Urgent Field Safety Notice

Manufacturer's reference: SB_RDC_2023_02

Important information related to the Accu-Chek Solo[®] diabetes manager's bolus data screen

Information swipe down screen:

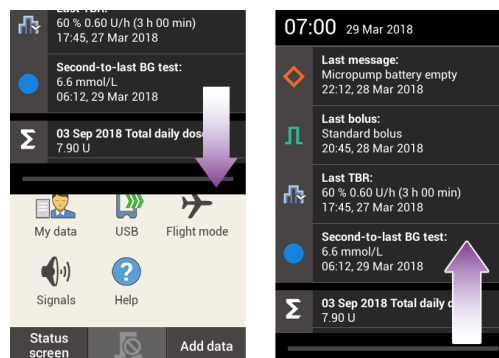
correct bolus data shown however if you tap on the "Last bolus" you will be taken straight to the "Bolus data" screen, so please **do not** take this step

EN Display error on Bolus data screen

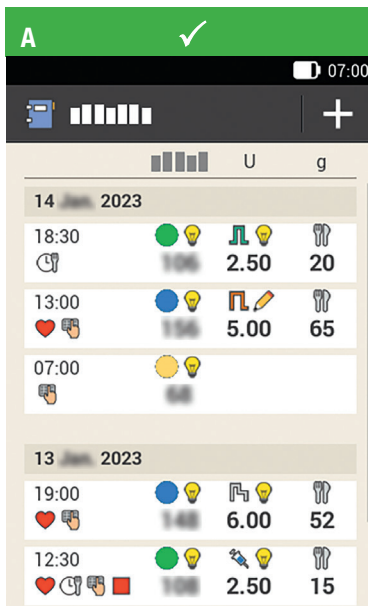
The **Bolus data** screen (B) contains an error that may cause incorrect bolus data to be displayed.

✗ Do not refer to the **Bolus data** screen (B) for information purposes.

✗ Do not make therapy decisions (for example, delivery of a meal bolus or correction bolus) based on the data of the **Bolus data** screen (B).

✓ Always use the **Logbook** screen (A) to review your past bolus data:

Tap **Main menu** > **My data** > **Logbook** to access the Logbook.
